REFERENCE LHC-EQCOD-EC-XXXX

ENGINEERING CHANGE REQUEST

First Phase of Installation of Low-Impedance Secondary Collimators (TCSPM) in IR7

Figure 1 — 3D view [5] of the TCSPM collimator, showing an extremity of the jaw with the embedded BPM, the “third” BPM for orbit measurements in the plane orthogonal to the collimation plane, and the new tapered transitions made of MoGr.

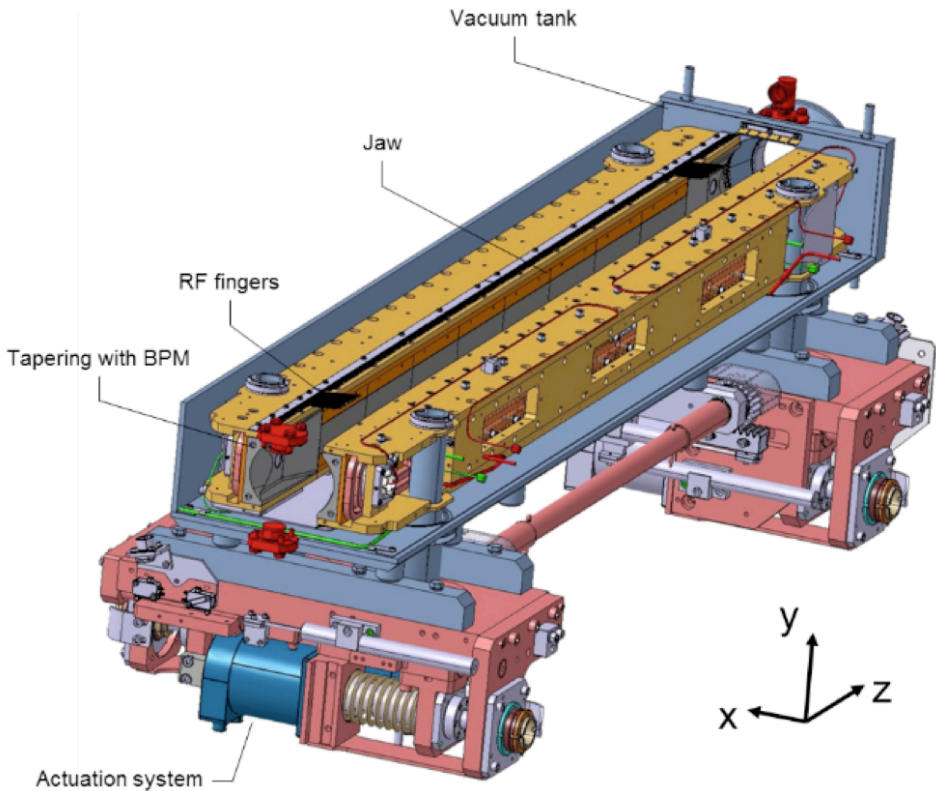
The present TCSPM design [5] (see Figure 1) [an evolution](#) the one of the present TCSGs [1]; among the most noticeable differences, there are material and coating of the jaw, and the presence of Beam Position Monitors (BPMs). [Other features re described in \[7\]](#). In fact, the design foresees jaws made of a composite material (MoGr) obtained from Molybdenum and graphite, chosen for its [similar robustness and superior impedance characteristics](#) with respect to the jaw material of the present TCSGs, [in particular since](#) a thin coating layer of Mo [will be deployed](#). The collimator jaws are equipped with BPM button pick-ups, for an easy determination of the beam closed orbit at the collimator and fast and precise alignment of the jaws. A third BPM is installed on the tank, to measure the beam position on the axis orthogonal to the one of cleaning.
